## OFFICIAL NOTICE OF DECISION

**Project# 1010181**

RE: Project #1010181, PNM Richmond Switching Station  
Site Development Plan for Building Permit

RE: DRB Comment Responses – Project #1010181 – Richmond Switching Station

<b>PNM</b> PUBLIC SERVICE COMPANY OF NEW MEXICO		
ELEVATION VIEW		V3
115KV LAYOUT		
RICHMOND SWITCHING STATION		
DR	TR	DATE 10/9/14
CKD	OK	SCALE
APP	ACAD FILE	SHEET 6 OF 6
REV NO

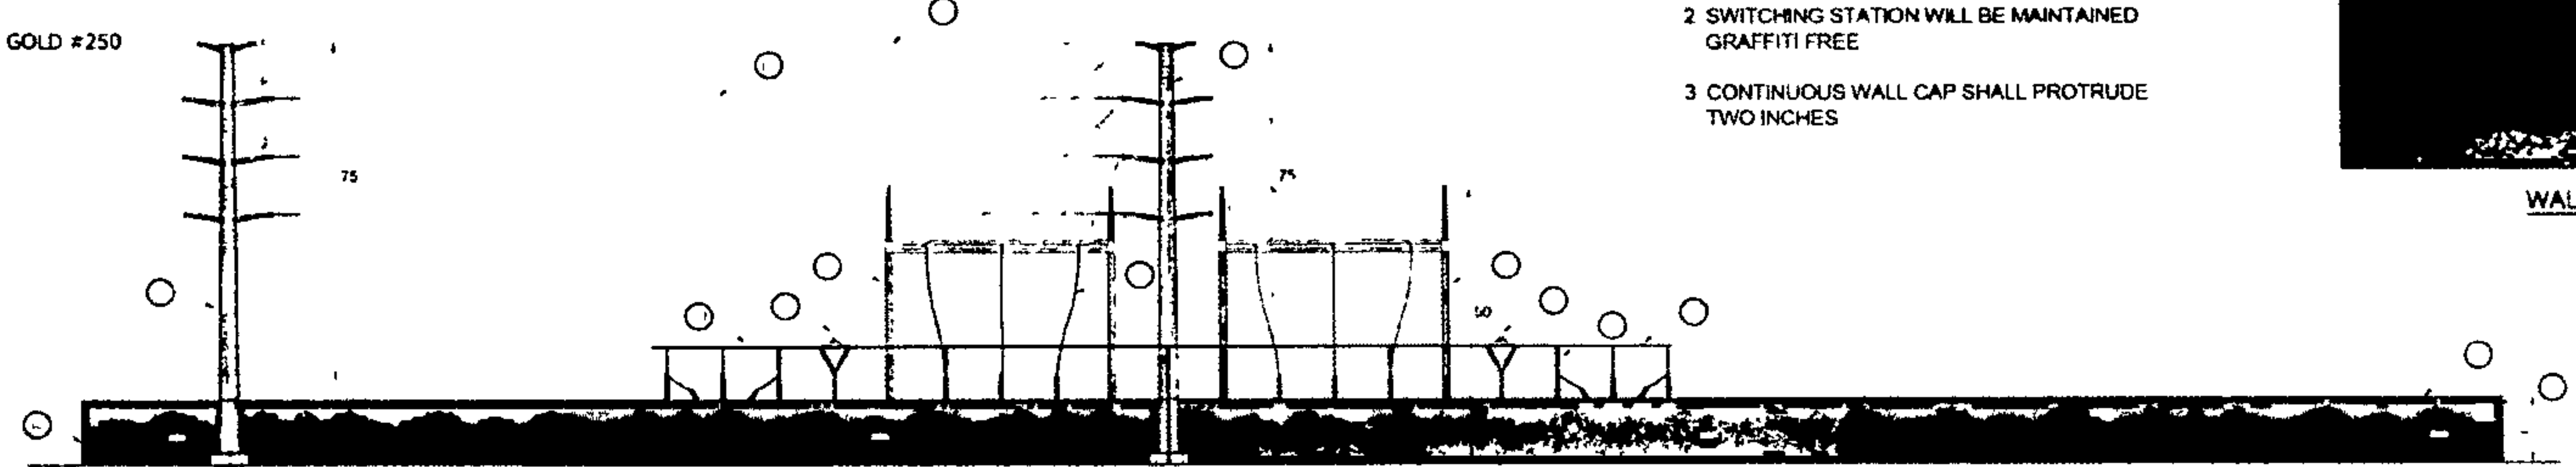
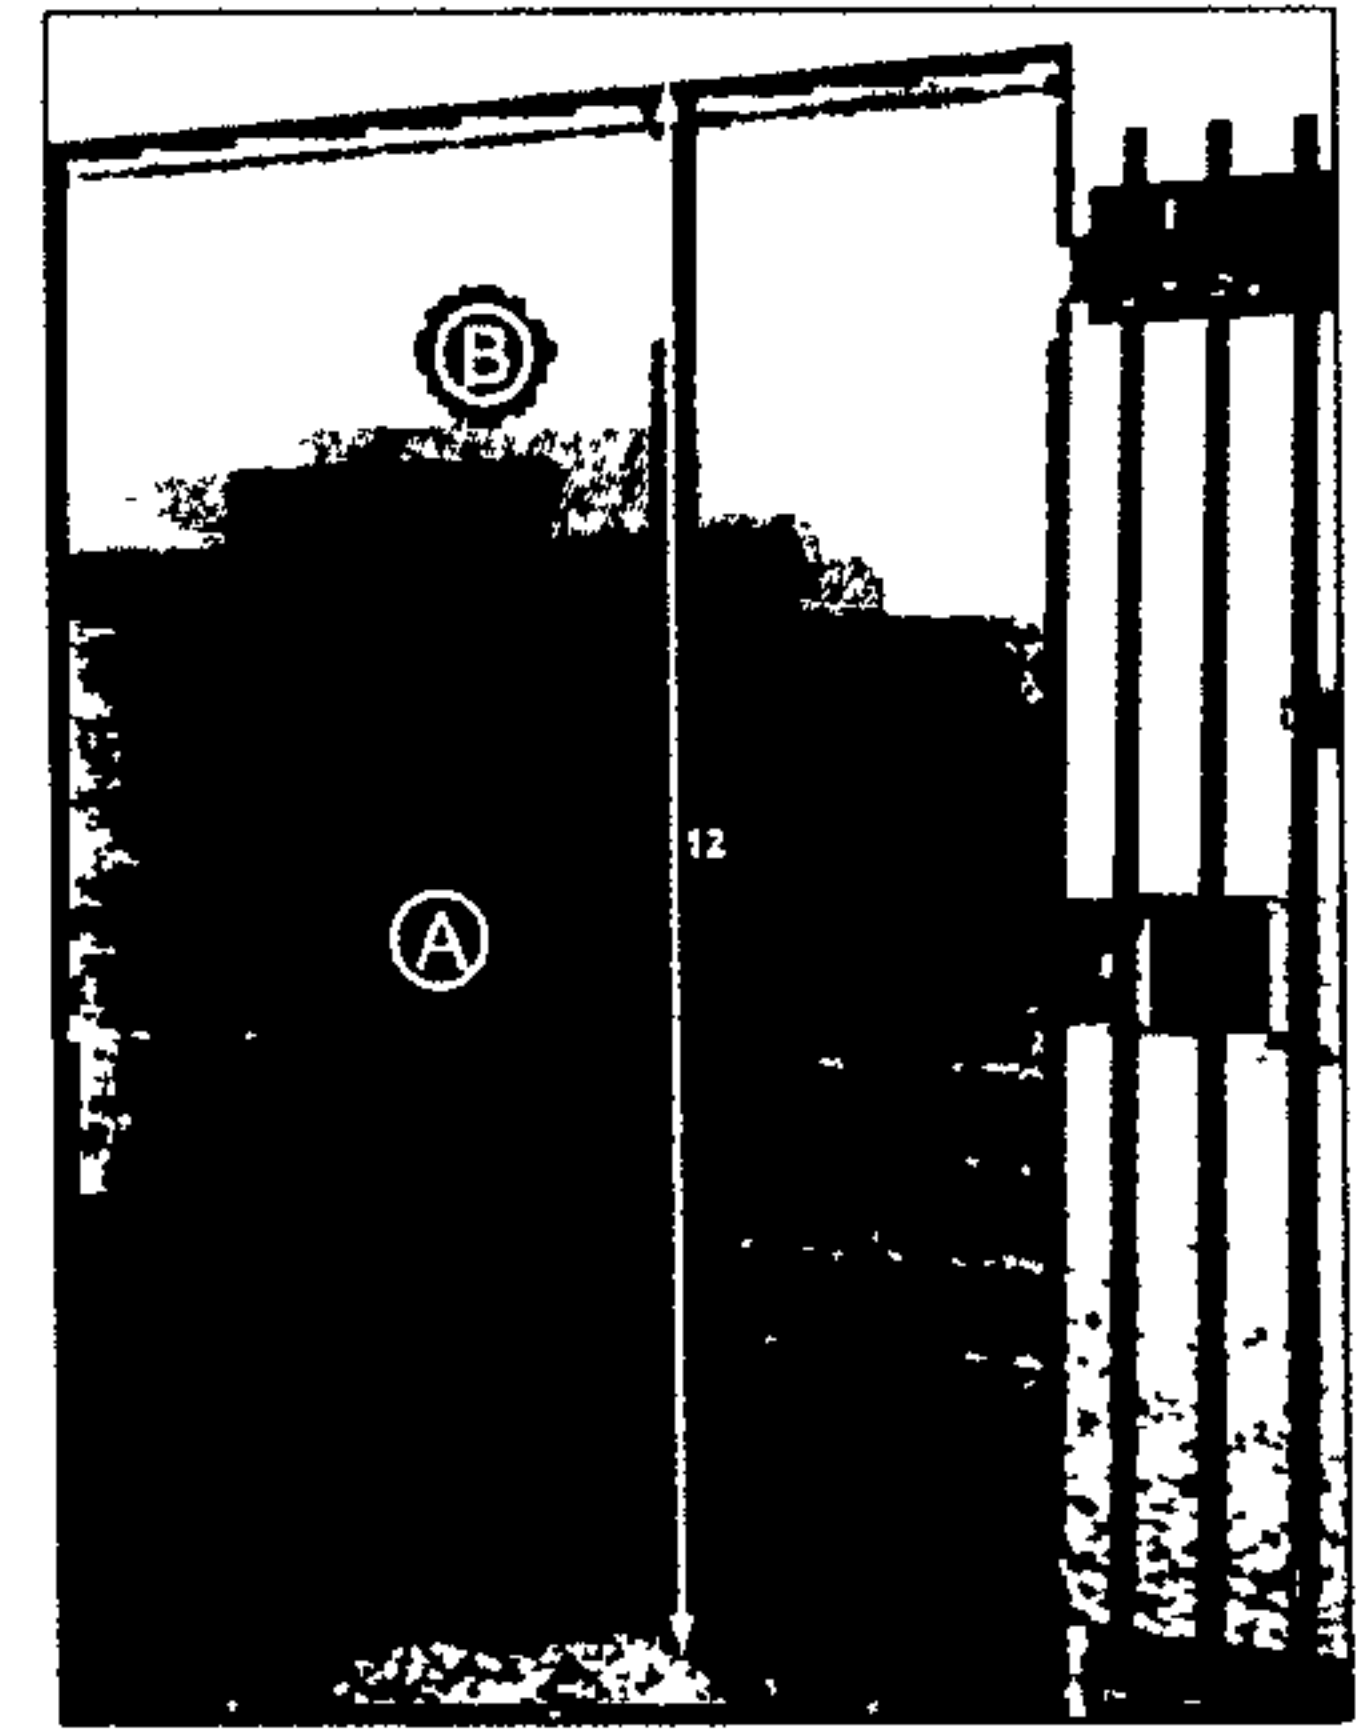
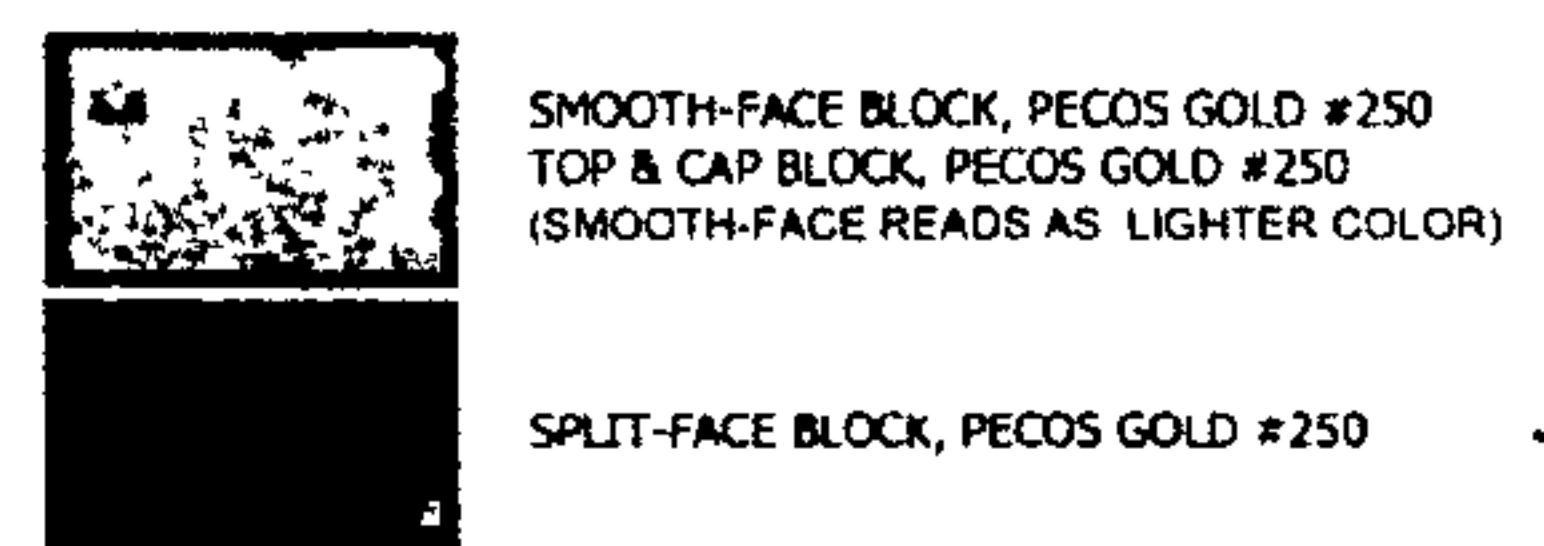
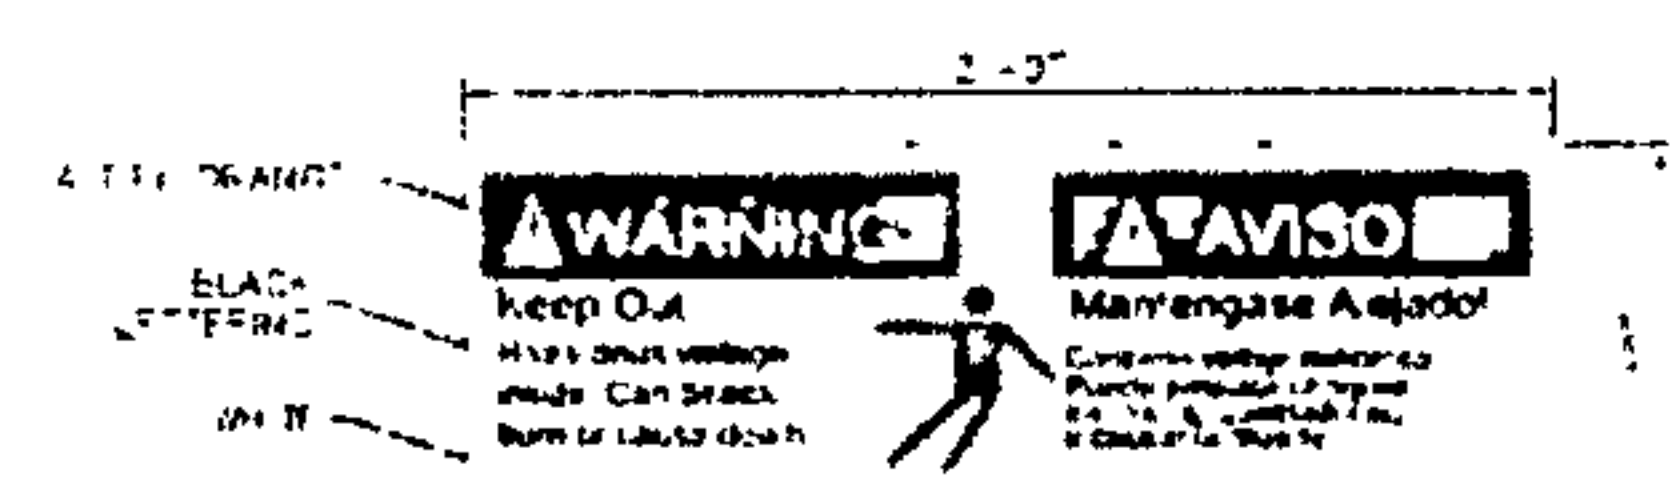
- a. The set I reviewed had two copies of Sheet 6 (one may be missing from another set).

- A. A note shall be added to state that the switching station will comply with NEMA noise guidelines (Design Standard #11).
- B. A note shall be added to state that the switching station will be maintained graffiti free (Design Standard #15).

- A wall detail, in elevation view, shall be added to the detail sheet and specify dimensions, material(s) and colors.
- The split-faced and smooth-faced block shall be noted as different colors so they match the color rendering.
- The continuous wall cap shall protrude a minimum of 2 inches [ref: §14-16-3-19(C)(2)(b)(1)(d)]. *Note correct reference cited.*

*All sheets are included in the proper order in this submittal.*

*The following notes have been added on V.3 on Sheet 5 of 6 and Sheet 6 of 6:*

- A wall detail has been added to V.3 Sheet 5 of 6 and Sheet 6 of 6 specifying wall dimensions, materials and colors.*
- Photos of Pecos Gold #250 split-face and smooth-face block have been added to V.3 Sheet 5 of 6 and Sheet 6 of 6. A note has been added to V.3 Sheet 5 of 6 and Sheet 6 of 6 that states, "SMOOTH-FACE READS AS LIGHTER COLOR."*
- A note has been added to V.3 Sheet 5 of 6 and Sheet 6 of 6 that states, "CONTINUOUS WALL CAP SHALL PROTRUDE TWO INCHES."*
